Meridian Firs Apartments Deck Repair

Casey + DeChant Architects, LLC Architecture And Planning

A1.0

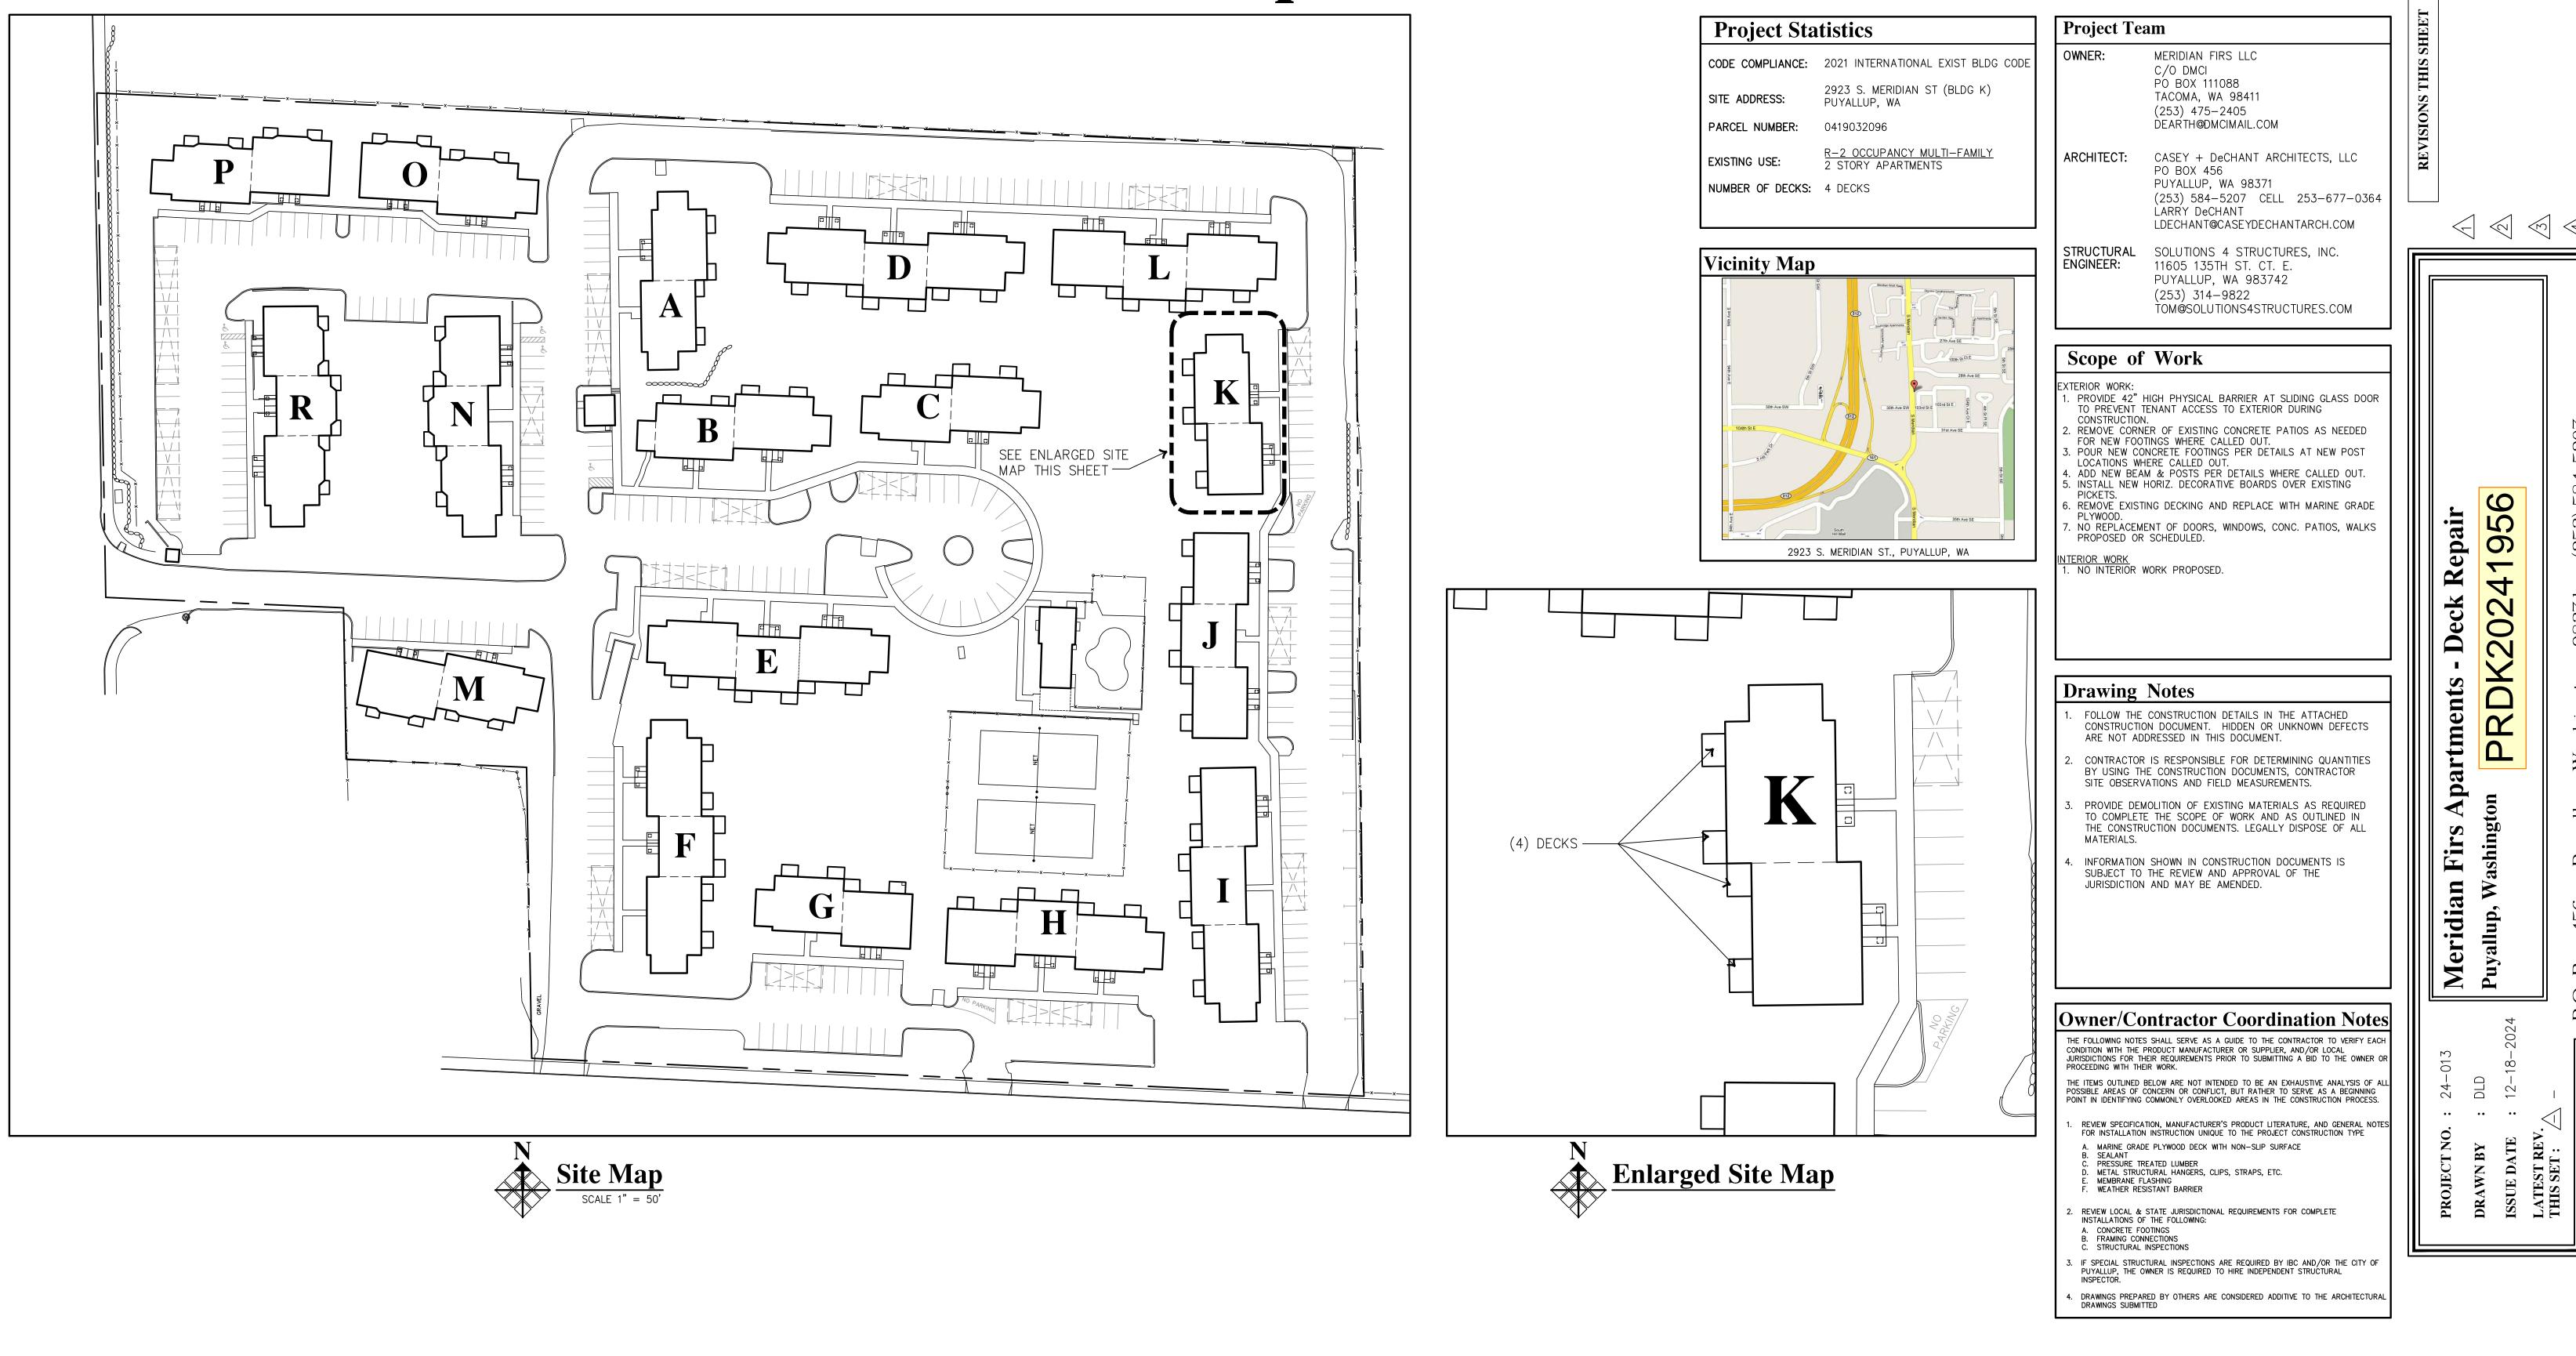
Provide specifics of the plywood that will be installed which should include plywood thickness, grade and any other specifics that will reflect that the plywood will withstand the dead and live loads of the deck. Identify the non-slip surface that will either be provided on the plywood or will be added to the plywood as part of construction, as notated on sheet A1.0, Owner/Contractor Coordination Notes.

requested information.

(Construction Plans, Sheet A1.1)

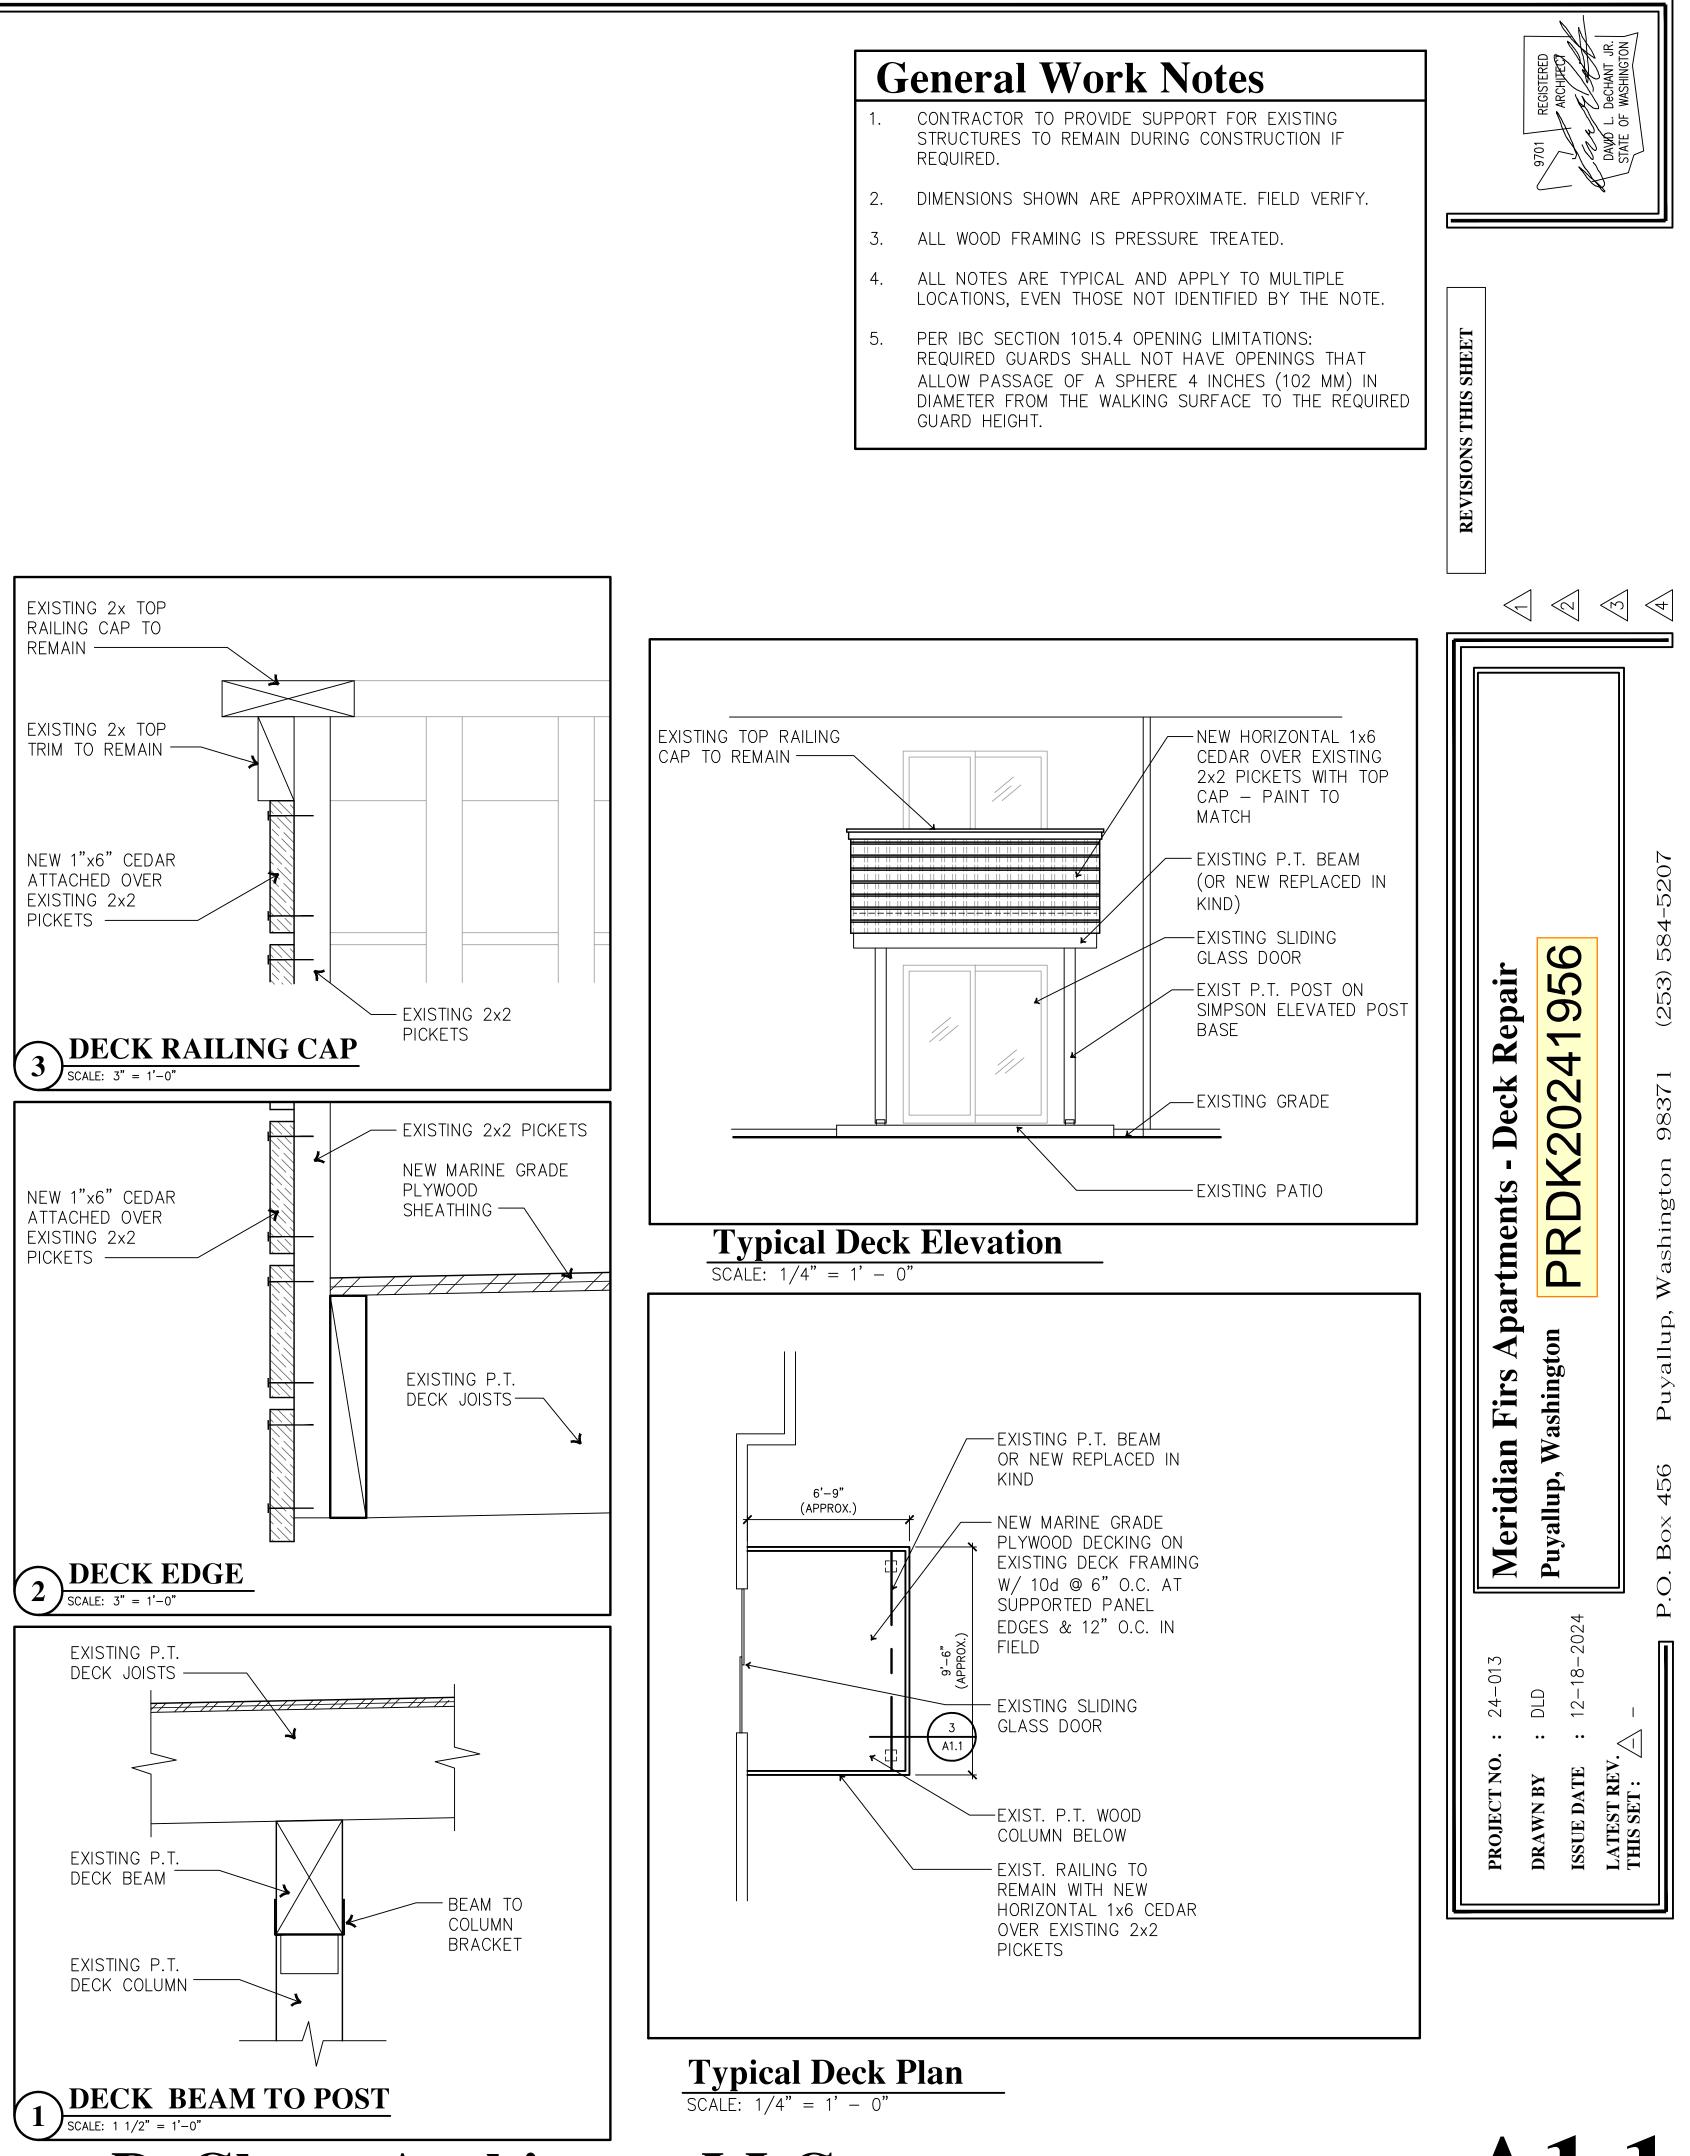
Determine the minimum required specifications for deck beams, posts, post bases, post caps and footings if replacements are necessary. Given the work already completed and the stop-work order in place, establish a clear benchmark to assess the completed work and provide clarity for future construction and inspection, minimizing any potential ambiguities.

Deck joists appear to be sloped to drain off of the cantilevered side of each deck based upon details 1 and 2. Detail 2 shows the installation of the 1x6 cedar board over the existing 2x2 balusters. detail or notate how the 1x6 cedar will be installed to prevent drainage and water accumulation on the deck surface.

The existing joist spacing should also be considered when selecting the plywood material that will be used. Please provide the existing joist spacing.

Add a notation on either Sheet A1.0 or A1.1 that contractor shall verify the integrity of balusters prior to the installation of the 1x6 cedar. Establish the parameters of the balusters replacement to include type, grade and nailing pattern.

Updated all details and notes as needed to reflect the
